1990 Corvette: Service Bulletin: L98 and LT5: Revised Air Conditioning Control Circuit Diagnosis

Subject: REVISED AIR CONDITIONING CONTROL CIRCUIT DIAGNOSIS

Model and Year: 1990 CORVETTE WITH 5.7L L98 AND LT5 ENGINES

Bulletin Number: 90-400-6E

CHART C-10

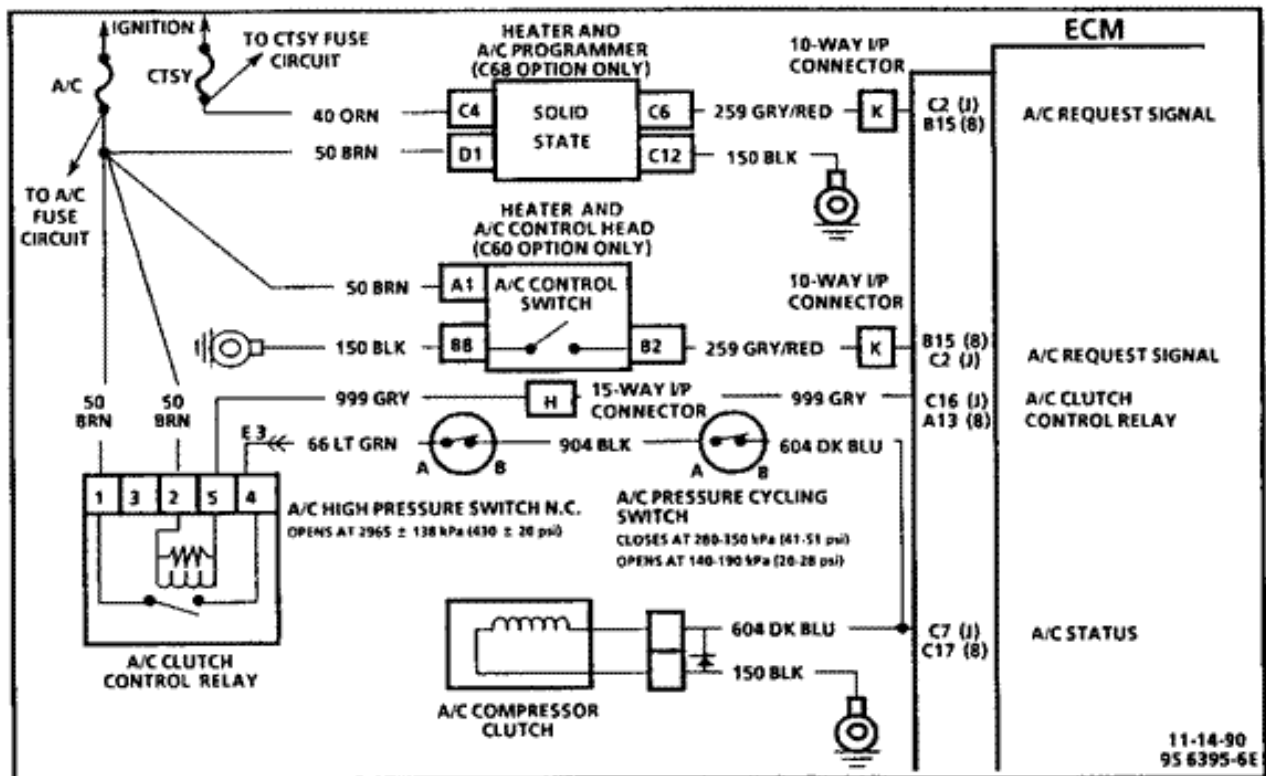
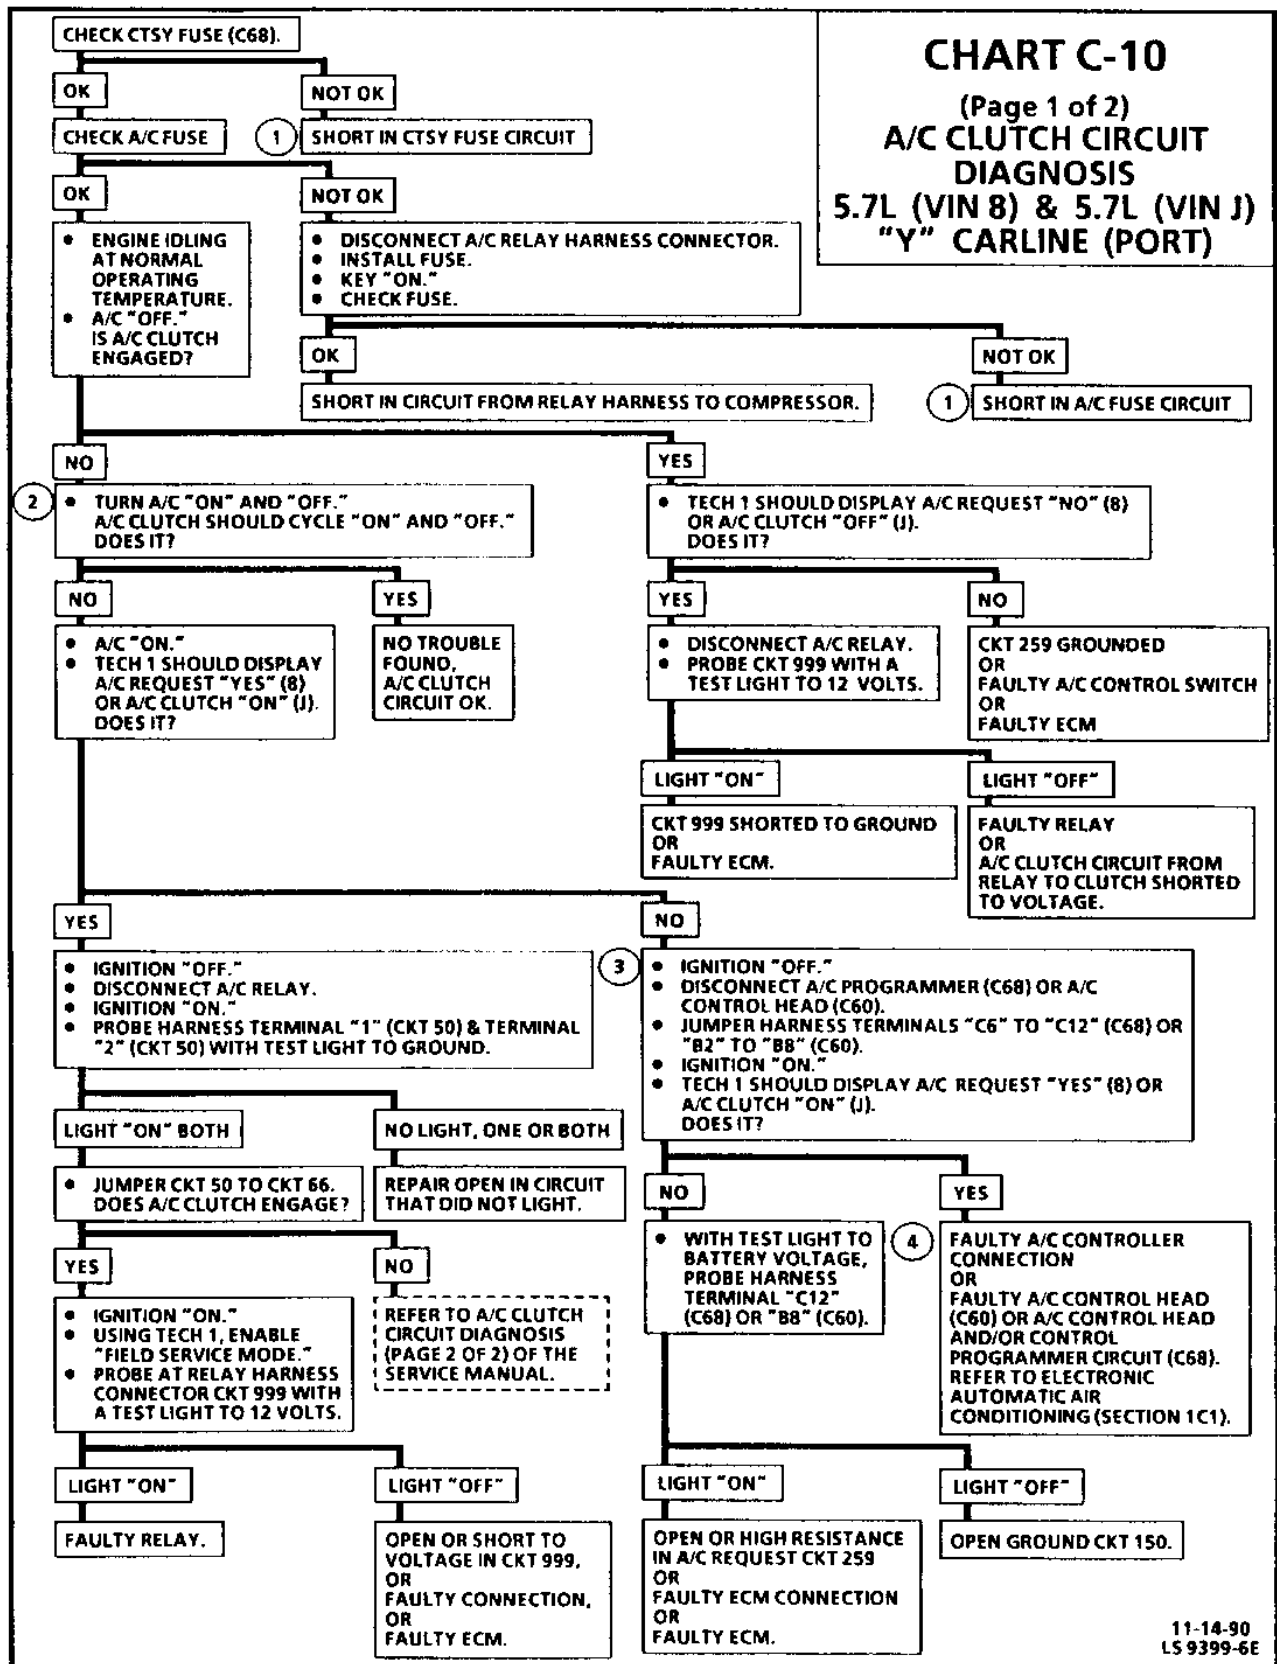
The following information updates the A/C clutch circuit diagnostic chart and facing page information found on pages 6E3-C10-4 and 6E3-C10-5 in Section 6E3 "Driveability And Emissions" for the 1990 "Y" 5.7L L98 (VIN 8) and LT5 (VIN J) Corvette Service Manual.

The A/C clutch control relay is ECM controlled to delay A/C clutch engagement after

the A/C is turned "ON." This allows the ECM to adjust engine rpm before the A/C clutch engages.

The ECM will engage the A/C clutch any time A/C has been requested unless any of the following conditions exist.

- o High coolant temperature.
- o Wide open throttle.
- o High oil temperature.
- o Sustained high vehicle speeds (LT5).
- o High engine rpm.

The ECM can determine A/C request by sending a voltage signal to the A/C control head. When the A/C control switch is closed, the A/C request voltage signal is grounded. This is shown on the Tech 1 as A/C request "YES" (8) or A/C clutch "ON" (J).

When a request for A/C has been detected by the ECM, the ECM will ground the A/C clutch control relay drive circuit, the relay contacts will close and energize the compressor clutch portion of the circuit. If the system is properly charged, the circuit will be complete to the A/C compressor clutch.

When A/C request has been detected by the ECM, the cooling fan(s) will be turned "ON" unless vehicle speed is too high.

1. Refer to ELECTRICAL DIAGNOSIS (SECTION 8A) "FUSE BLOCK DETAILS" for fuse circuit power distribution.
2. Checks the ECM's ability to control the A/C clutch control relay.
3. Checks to determine if the ECM is capable of detecting the A/C request signal being grounded.
4. Before replacing C68 A/C control components," refer to ELECTRONIC AUTOMATIC AIR CONDITIONING (SECTION 1C1) for further A/C diagnostics.
